**SUSQUEHANNA STEAM ELECTRIC STATION
SUPPLEMENT 3 TO PROPOSED AMENDMENT NO. 239
TO LICENSE NPF-14 AND PROPOSED
AMENDMENT NO. 204 TO LICENSE NPF-22:
HPCI AUTOMATIC TRANSFER TO SUPPRESSION
POOL LOGIC ELIMINATION
PLA-5470**

**Docket No. 50-387
and 50-388**

Attachment 1 – Response to RAI

Figure 1 Effect of reducing maximum kinetics time step size from 1 second to 5 msec for SABRE Case 8 of EC-ATWS-0505, Rev. 8.

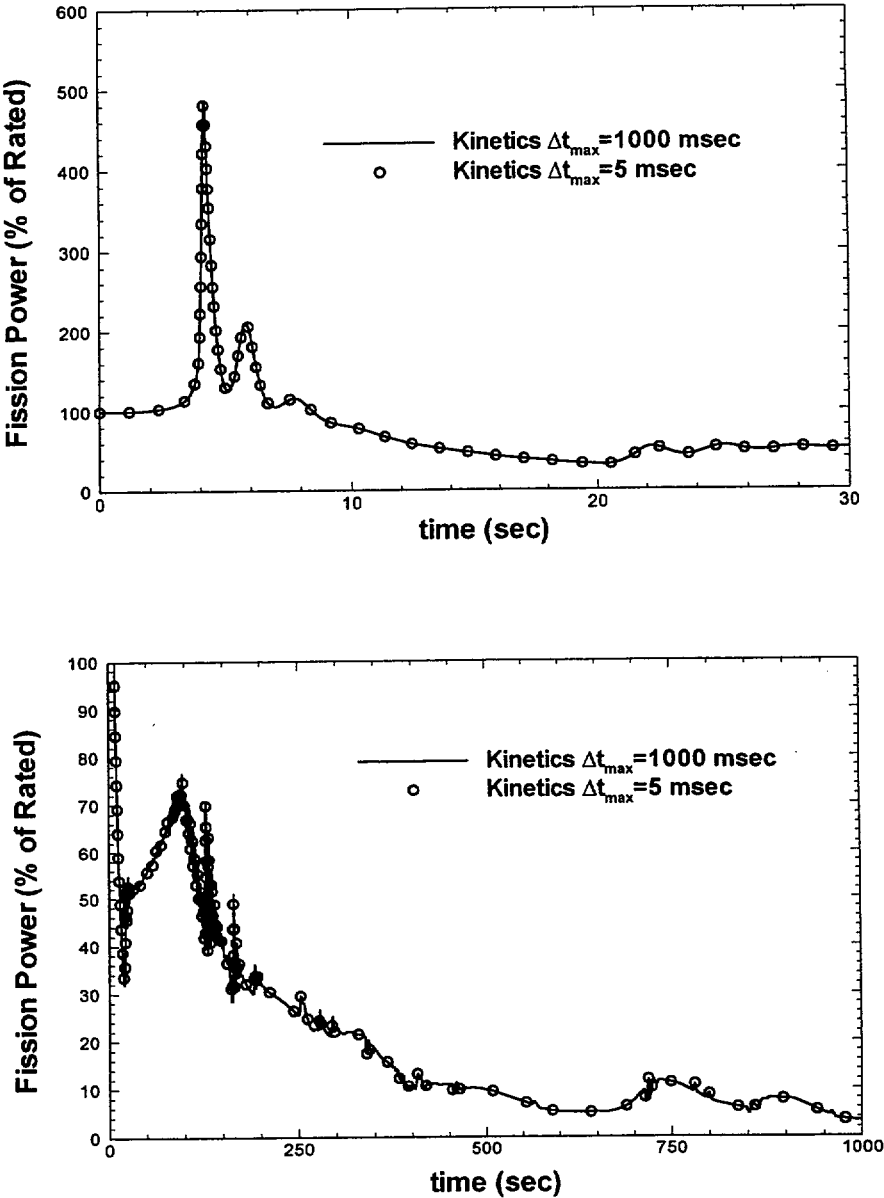
It is observed that SABRE computer code uses different time step sizes for thermal hydraulic calculations and neutronics calculations. Please explain how the core power calculation is synchronized with the fluid and heat transfer calculation. The impact on accuracy needs to be discussed. Please provide a comparison between the unsynchronized and synchronized results.

Sensitivity studies on hydraulic and neutronic time steps have been carried out in §5.8 (MSIVC ATWS) of EC-ATWS-0505, Rev. 8. Figures 5.8-3 and 5.8-4 show the effect of reducing the hydraulics step size while keeping error criteria constant for LSODES. There is a small change in peak power but no change in peak suppression pool temperature. Figures 5.8-6 and 5.8-7 show the effect of reducing error limits for neutronics calculation by an order of magnitude while the hydraulics step size is held constant. There is no noticeable change in the results. Therefore, it is concluded that the sequential solution procedure gives accurate results.

Results of an additional sensitivity study are included along with this response to demonstrate that the automatic time step control algorithm used in LSODES gives accurate results for neutron power. Case 8 in Calculation EC-ATWS-0505, Rev. 8 is an MSIV Closure ATWS with boron injection. This case was run with a maximum allowable kinetics time step of 1 second (1000 msec). With this restriction, the LSODES solver will select a time step size based on specified error criteria which are supplied as part of the SABRE input data. If the step size is less than or equal to 1 second, it is used in integrating the two-group diffusion equations, if it is greater than 1 second, the step size is limited to 1 second. This case was rerun using a much smaller maximum kinetics time step size of 5 msec. This maximum step size corresponds to the hydraulic time step size for the first 30 seconds of the transient. Fission power results for the two calculations are plotted in the attached Figure 1, (Page 18 of Attachment 1). It can be seen that there is no noticeable difference in the calculated fission power. Detailed numerical results for the two calculations are included on the CD included within Attachment 1 of this submittal. Output for SABRE Case 8 of EC-ATWS-0505, Rev. 8 with maximum kinetics time step size of 5 msec is contained in file `sabre3v1.02-25.out`, and the output with maximum kinetics step size of 1 second is in file `sabre3v1.02-26.out`.
